NORTHEAST UTILITIES

Docket No. 50-423
B11180

Millstone Nuclear Power Station, Unit No. 3
Summary/Submittal of Revised Responses to PSB Mechanical Series Questions

Status of PSB Mechanical Requests for Additional Information

FIGURE Q430.73-1

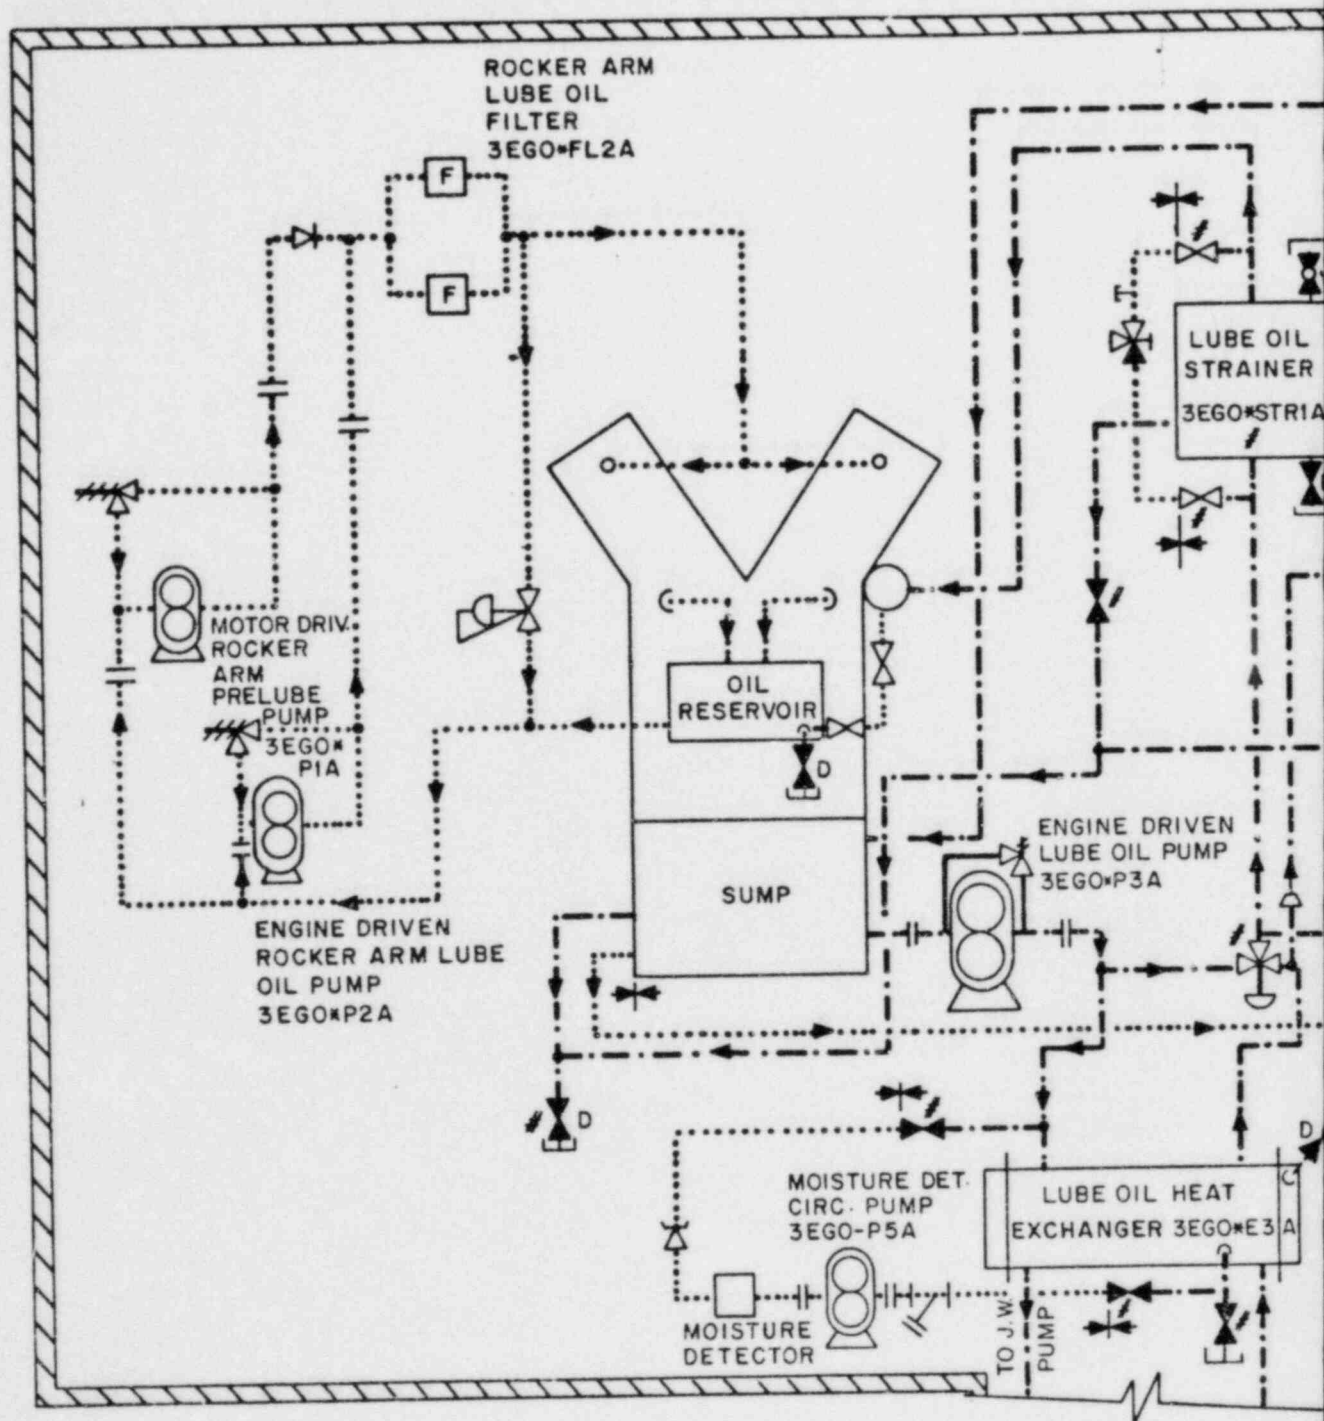
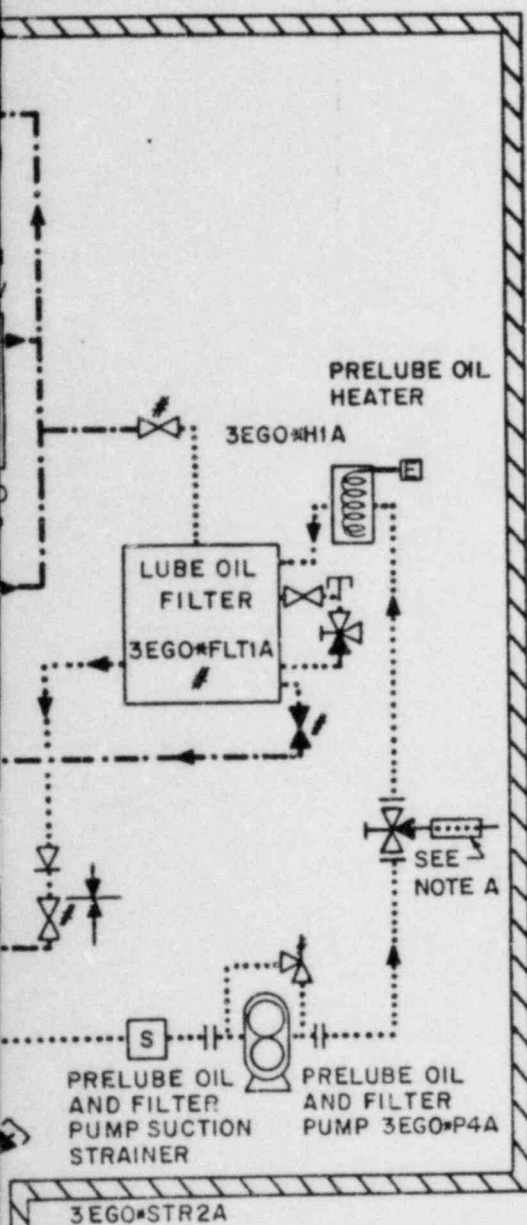
Question 430.73 (Section 3.2, 9.5.4, 9.5.5, 9.5.6, 9.5.7, and 9.5.8)

FSAR Figures Q430.73-1 through 430.73-4 show the on skid and off skid portions of piping systems and components. All piping and components are designed to seismic and Category I requirements. As can be seen from FSAR Figures Q430.73-1 through Q430.73-4, the piping up to the diesel skid interface is ASME 3, Class 3 for all auxiliary piping. The majority of on skid and engine piping is also ASME 3. Class piping that is not ASME 3, Class 3 is designed to manufacturers standards. The manufacturers standards are listed in Tables ~~9.5-2~~
